# City of Alamogordo

Re: **Addendum 1**  
**Public Works Bid No. 2021-005**  
**Alamogordo Park Restrooms**

Addendum Number 1 is issued to provide changes and/or clarifications to the questions asked on the above referenced bid. Date, time, and location of submitting this bid remains unchanged.

# E202R1

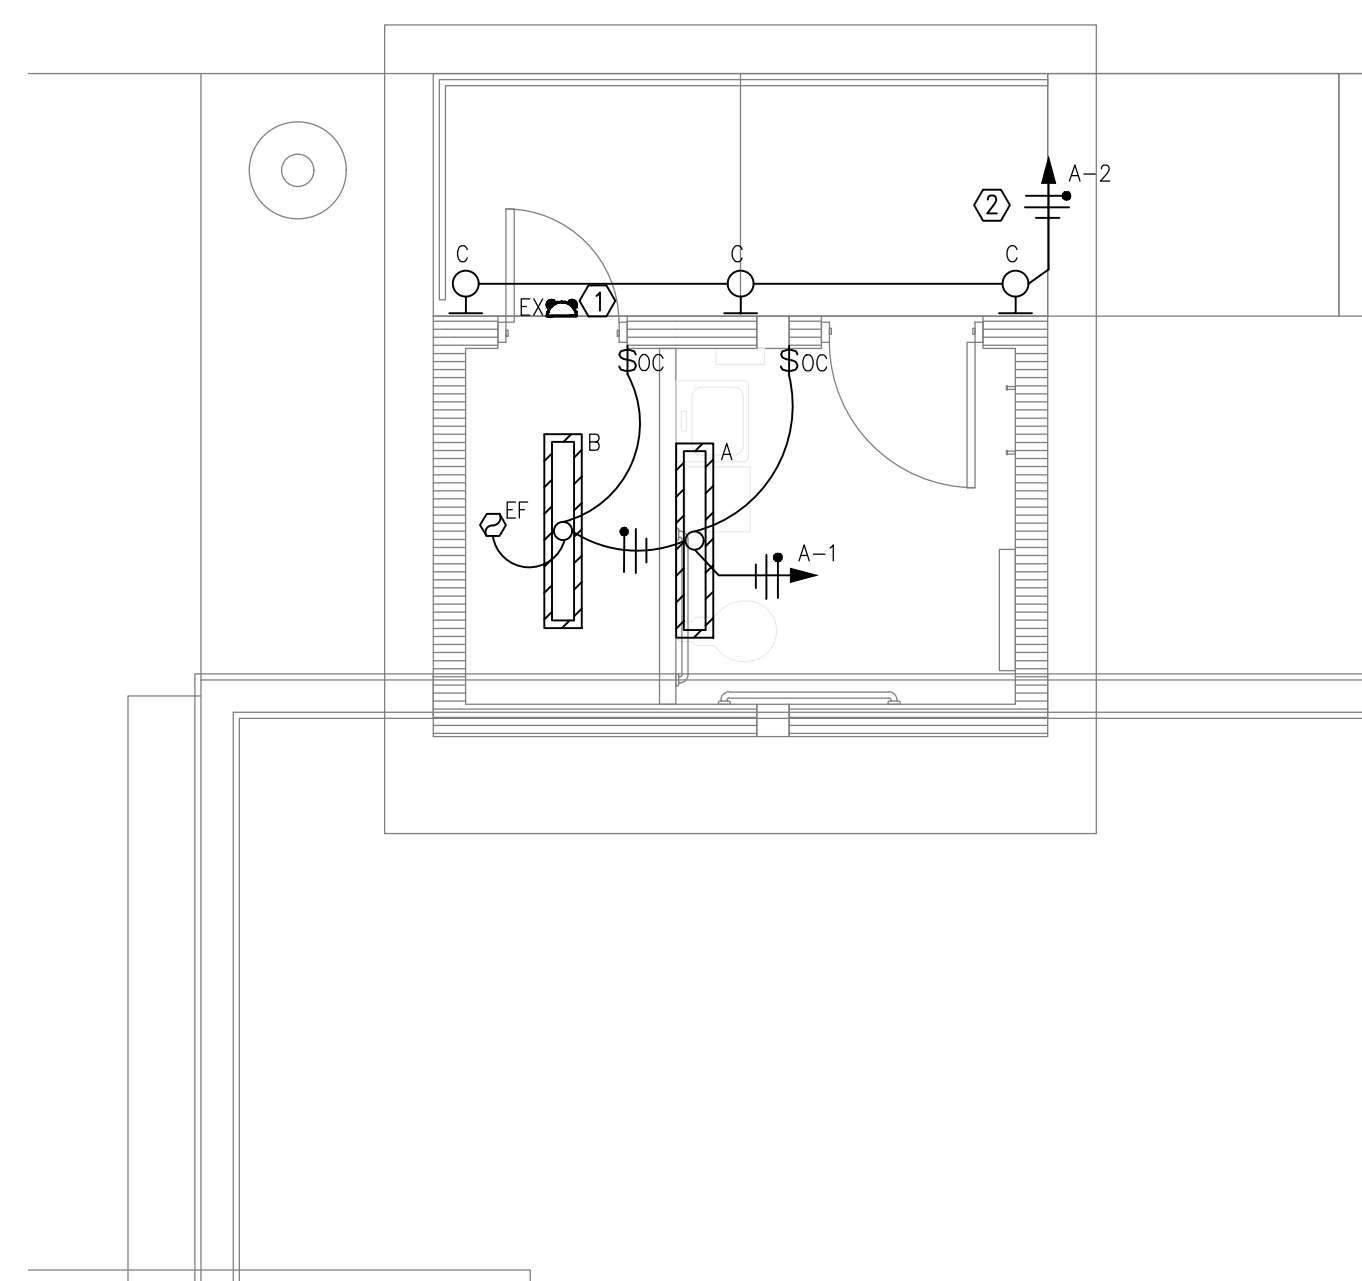
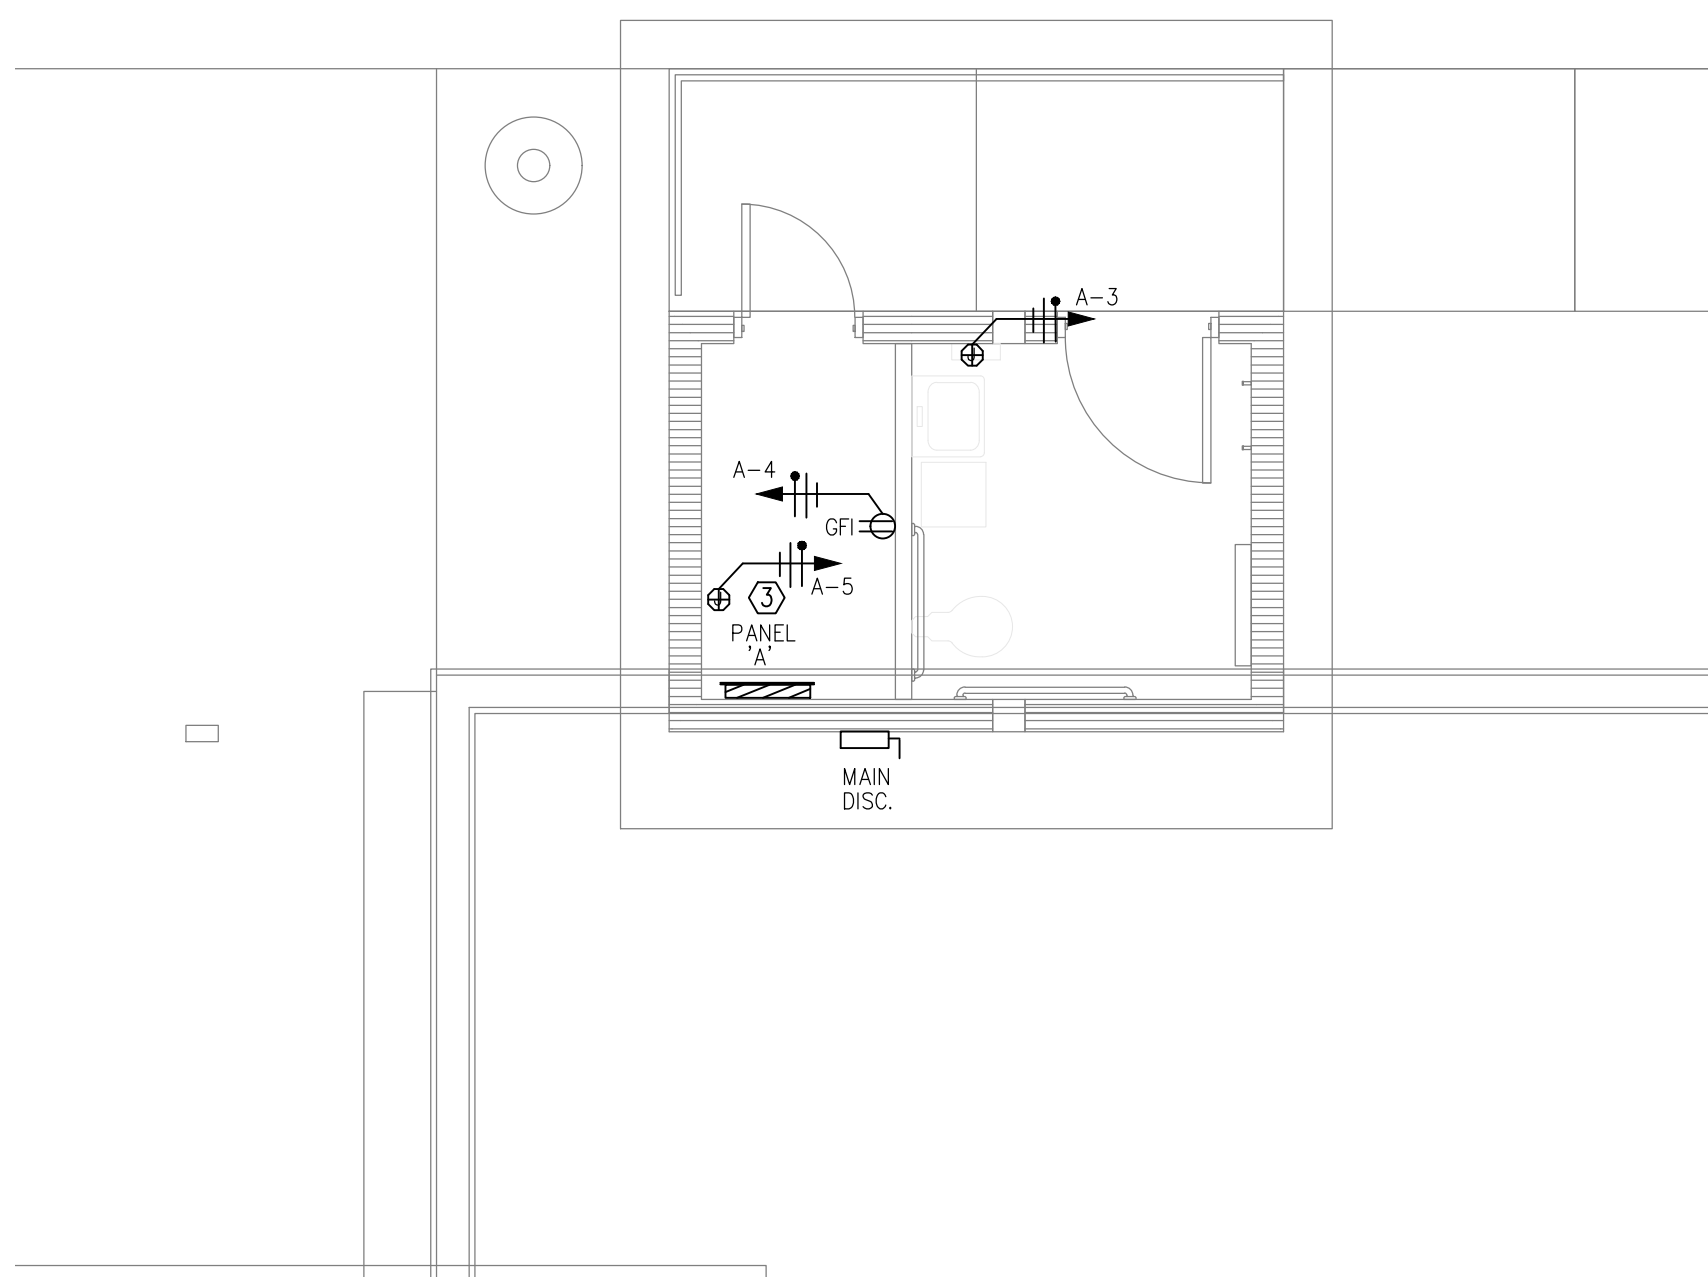
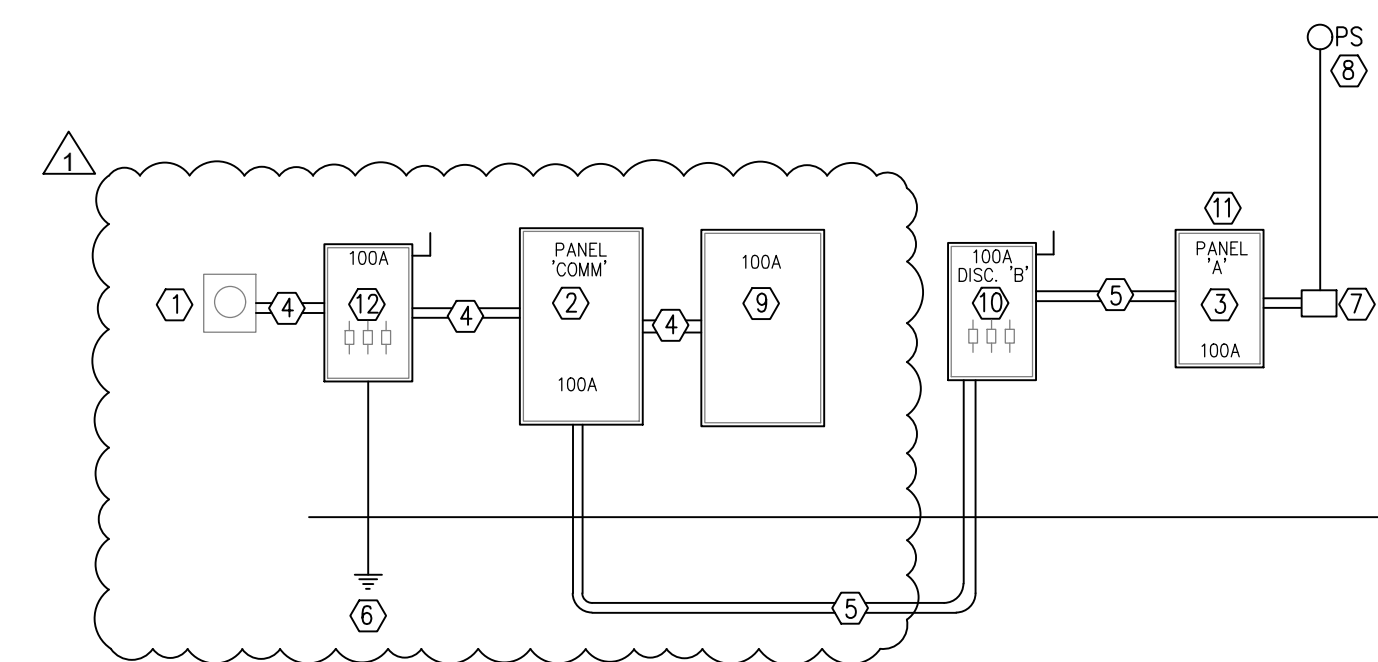
**Question 5** – Is the existing electrical panel located on the northwest corner of the education building at the zoo available to tie into for the new restroom?

**Question 10** – At the walk through it was discussed to get electricity supplied from the adjacent building rather than as shown on the plans. Is this the approach we should take? Will design details for this change be provided?

**Response 5** – Yes, power can be taken from this panel with some modifications to accommodate the increased load. See attached updated Electrical Sheets E102, E200R1, E201R1, and E202R1

**Response 10** – See response to question #5 and attached updated Electrical Sheets E102, E200R1, E201R1, and E202R1
